SUBJECT: Supplement B to the Application for Certification
Hidden Hills SEGS (11-AFC-2)

Response to Data Adequacy Review

**Hidden Hills Solar Electric
Generating System
(HHSEGS)**

(11-AFC-02)

Sheet 3 of 11

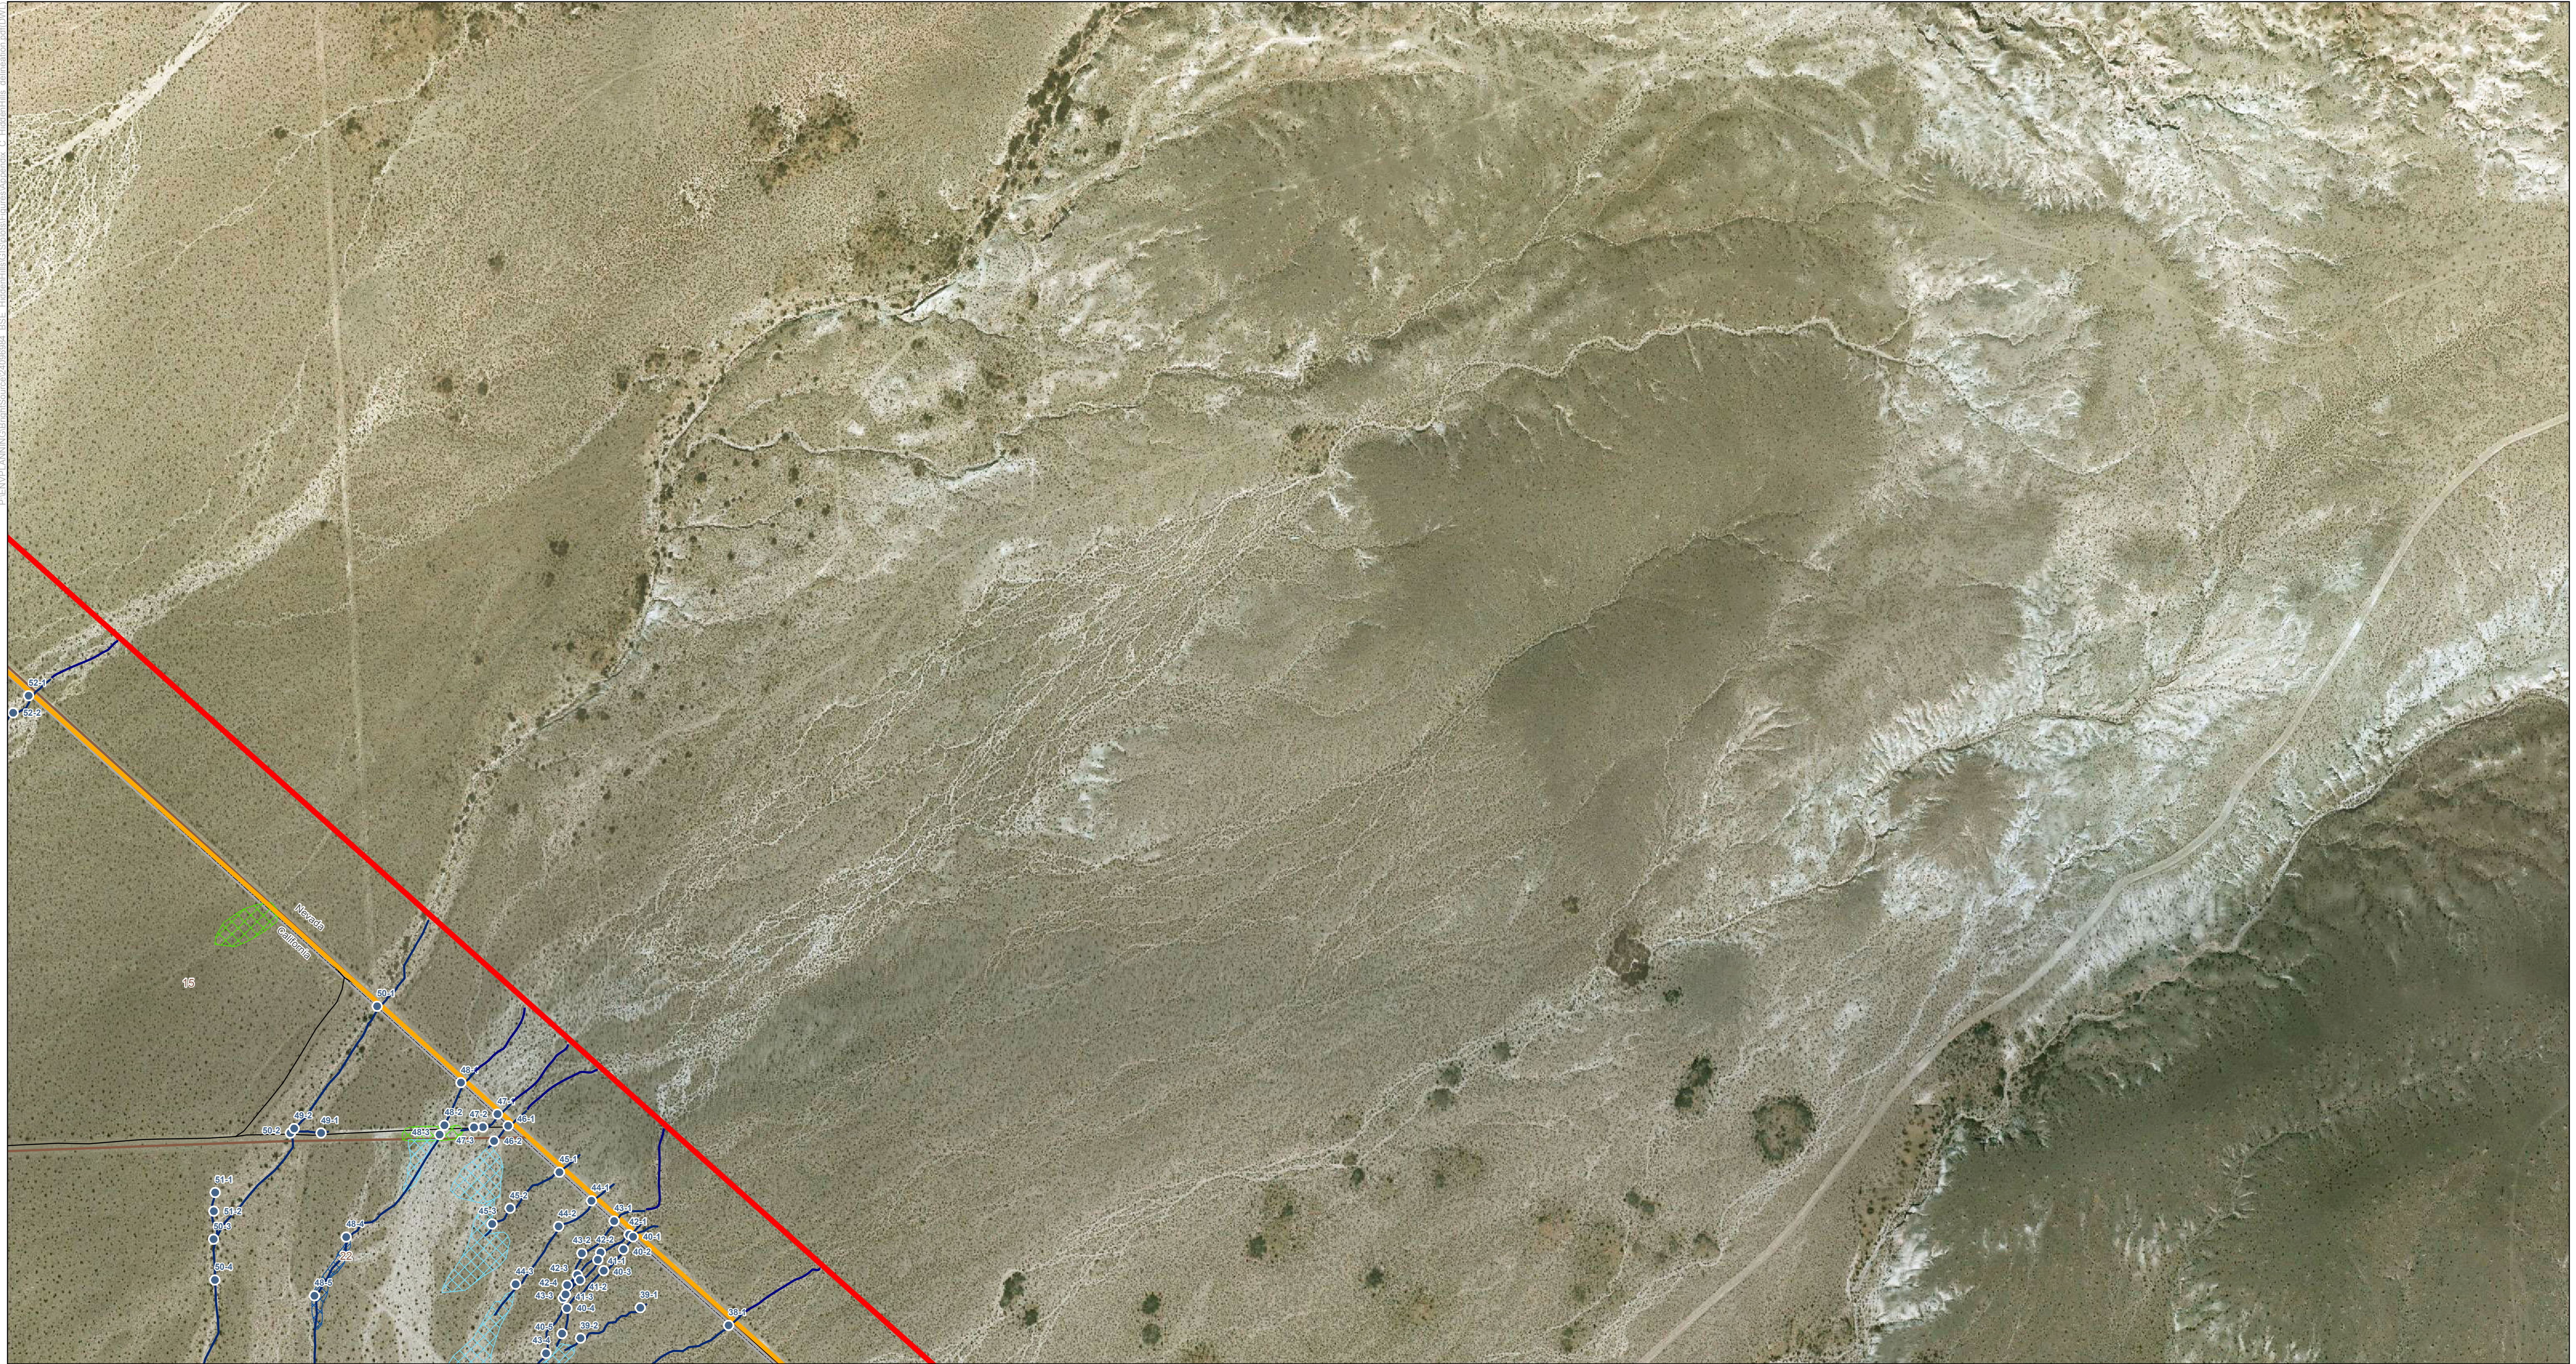
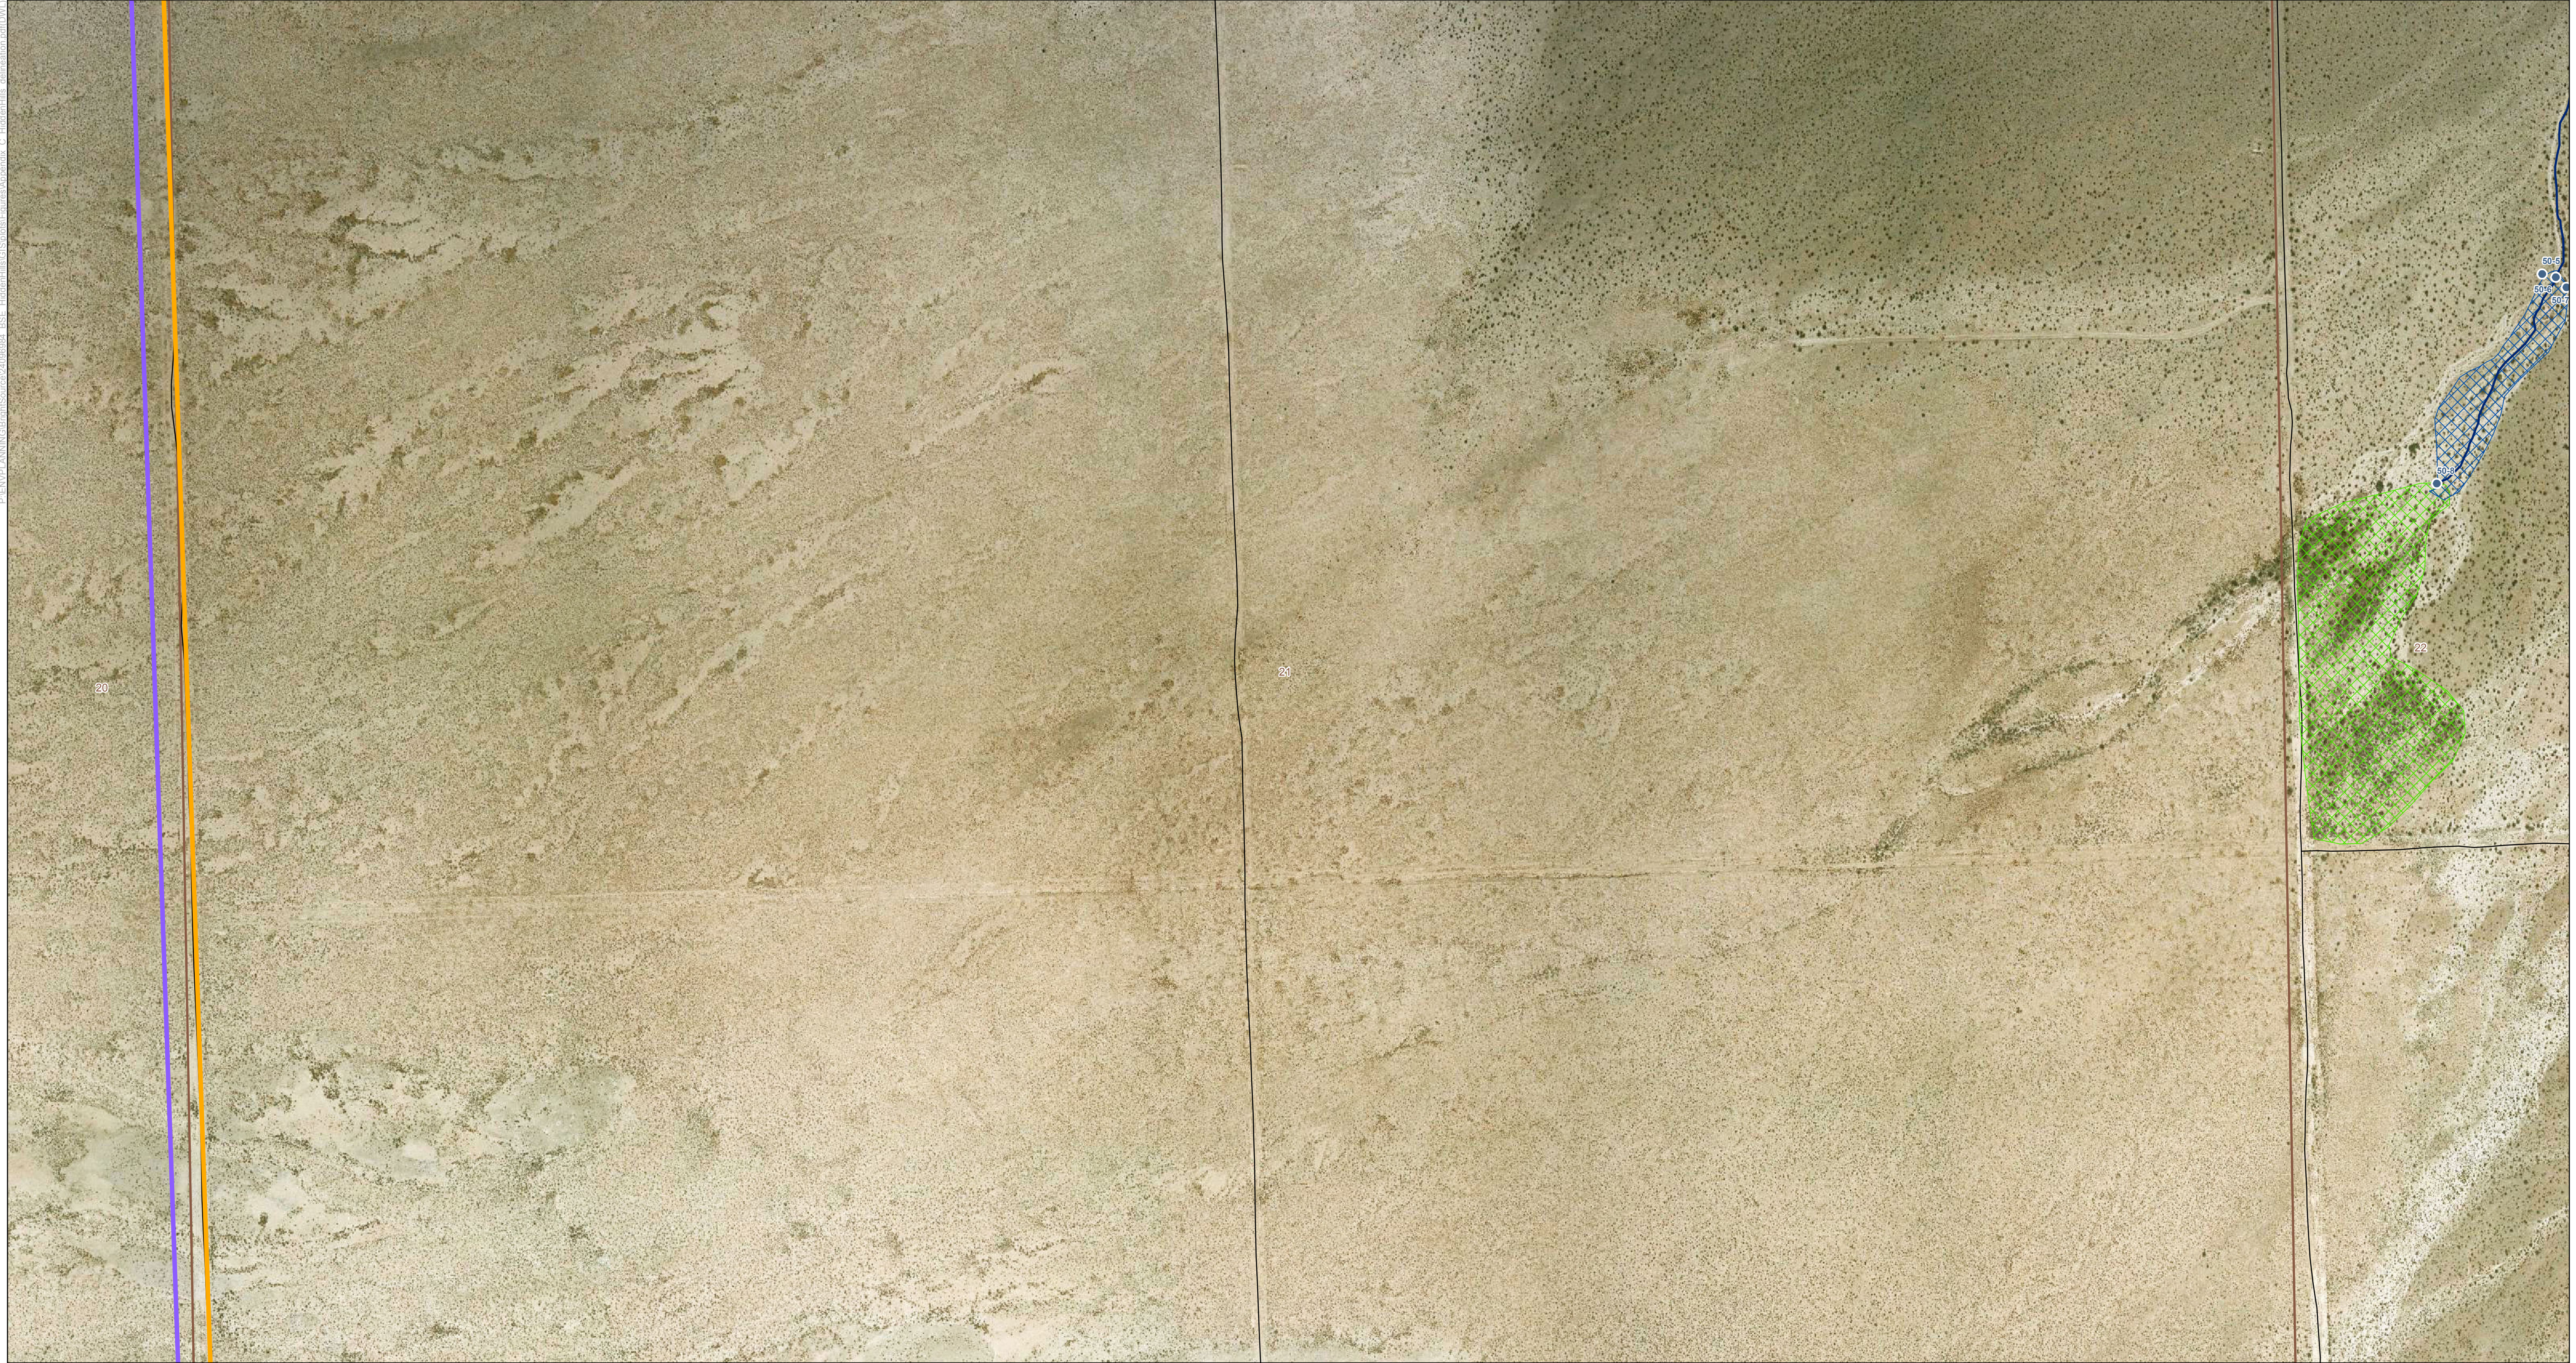
Please provide maps a scale of 1:2,400 showing any potential jurisdictional and non-jurisdictional wetlands delineated out to 250 feet from the edge of disturbance if wetlands occur within 250 feet of the project site and/or related facilities that would be included with the US Army Corps of Engineers (USACE) Section 404 Permit application. Provide an aerial photos or wetland delineation maps of jurisdictional and nonjurisdictional waters of the U.S. that occur beyond the project site to conform to the delineation out to the 250 foot buffer beyond the project boundary.

Response- Although these maps were provided in the initial September 2011 Data Adequacy submittal, there was a printing error and the delineation information for the 250-foot buffer was not clearly displayed. Five new sets of the drawings have been reprinted and the corrected maps are being provided to CEC staff as Attachment B2. Electronic copies will be provided to others upon request. The wetland delineation of
